Wildwood Manor Shopping Center, Limited Site Plan Amendment 82004016B

- Request to amend an approved Site Plan for a 4,971-square-foot building addition, realign vehicular access, improve landscaping, stormwater management, parking lot circulation and additional parking spaces;
- Location: 10233 Old Georgetown Road (MD 187) in the northeast quadrant of the Cheshire Drive intersection, Bethesda;
- Size: 11.6 acres;
- Split-zoned: CRT-0.75, C-0.75, R-0.25, H-35, NR-0.75, H-45 and R-90;
- 1992 *North Bethesda/Garrett Park Master Plan*;
- Applicant: Federal Realty Investment Trust;
- Accepted: 9/25/14.

SITE PLAN AMENDMENT RECOMMENDATION AND CONDITIONS

Figure 6: Meandering ADA-accessible sidewalk from Cheshire Drive

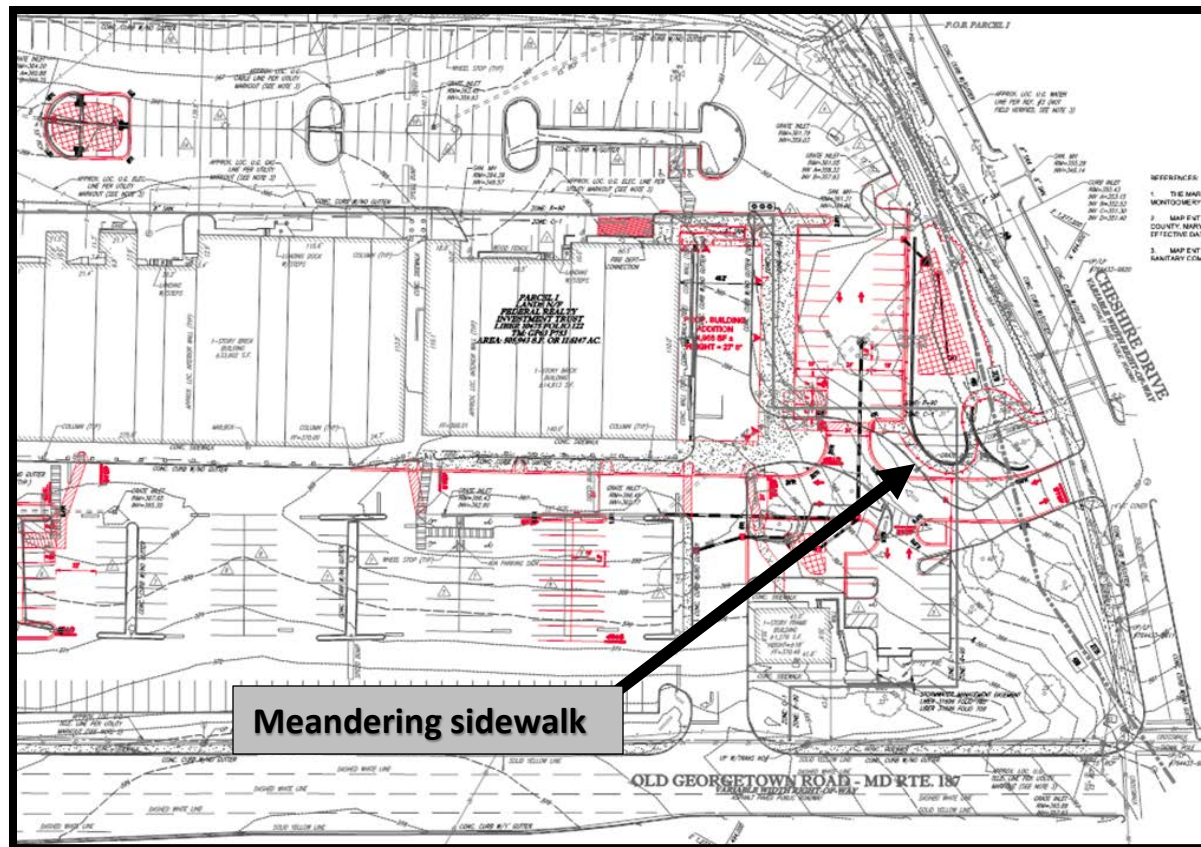
5. Prior to issuance of the final Use and Occupancy Certificate, the Applicant must upgrade the meandering pedestrian connection from the Cheshire Drive/Grosvenor Lane intersection, as shown on the Certified Site Plan.
